ADDENDUM NO. 1

DATE: December 5, 2017
FROM: City of Grand Junction Purchasing Division
TO: All Offerors
RE: Professional Engineering Services for Parks Raw Water Irrigation Supply Phase I

SETTLING BASIN
AND RESERVOIR

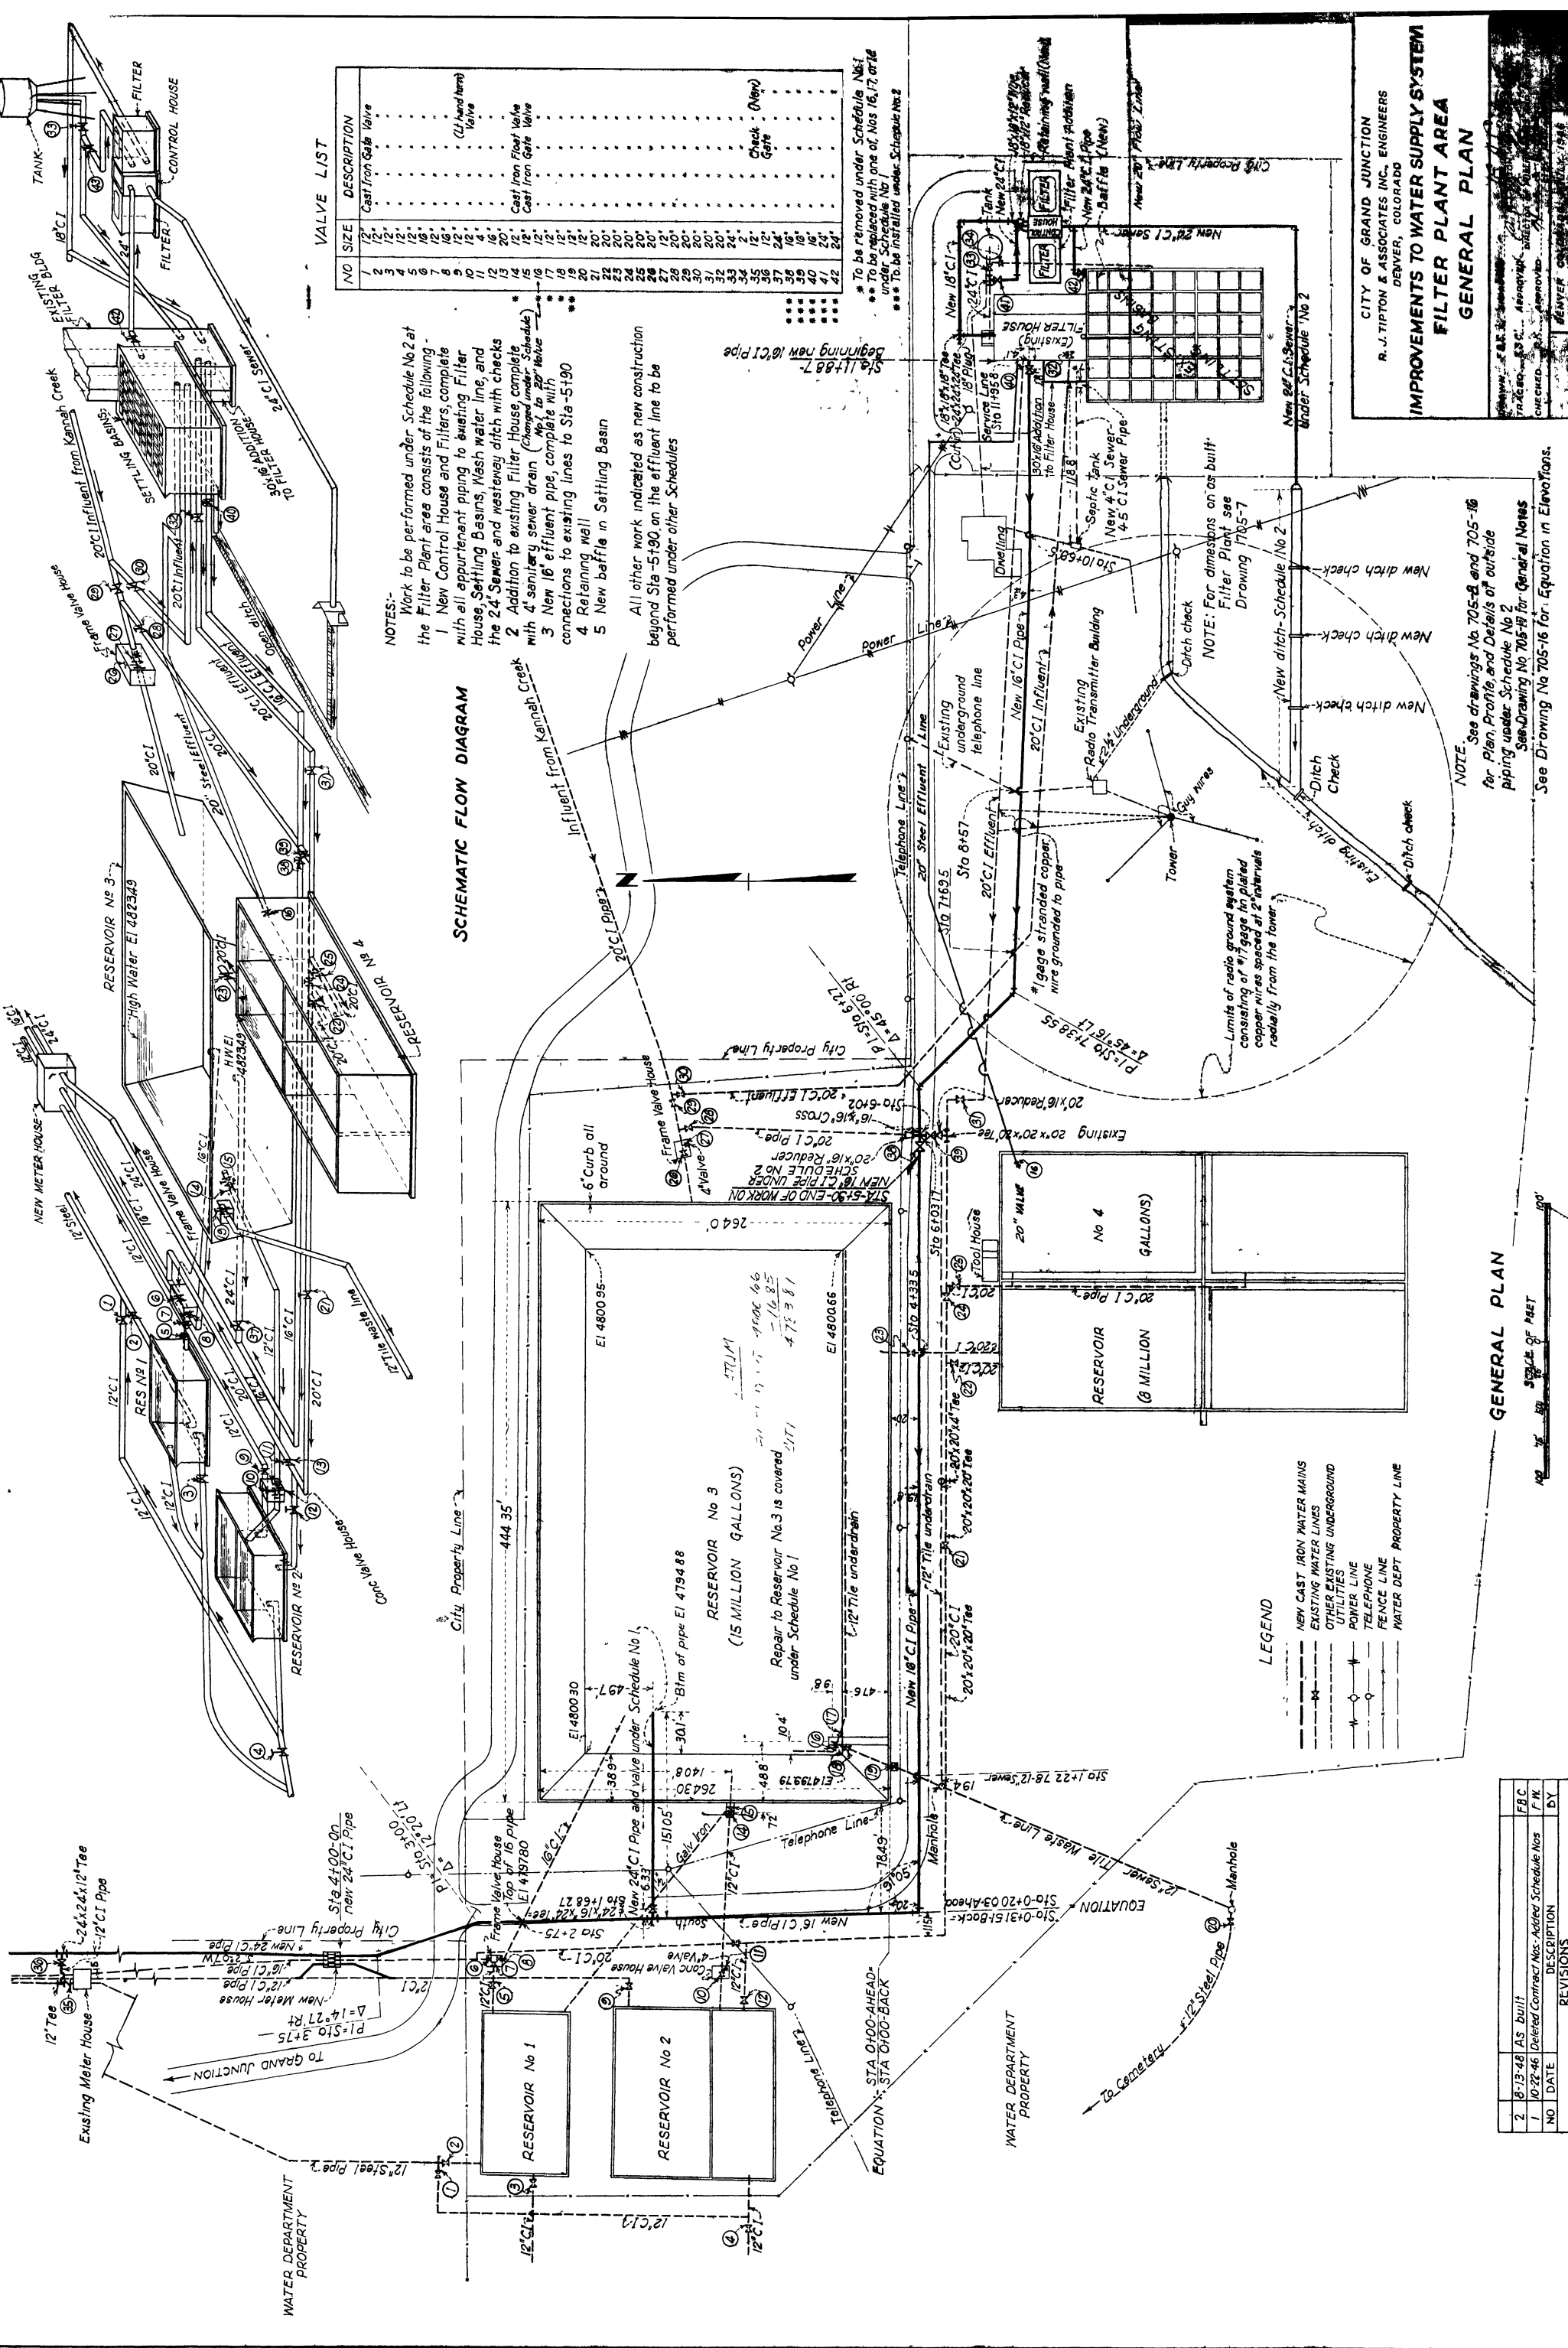
6. Q. Are "rights of ways" addressed for this project?
A. All rights of ways appear to be in order.
7. Q. Can the City provide "as-builts" for the reservoirs?

A. See Attached drawings:
 - a. Settling Basin
 - b. Improvements to Water Supply System Filter Plant Area – Asbuilt 1948
 - c. Duck Pond Park Lift Station Elimination – Water line Replacement Plans - 2005
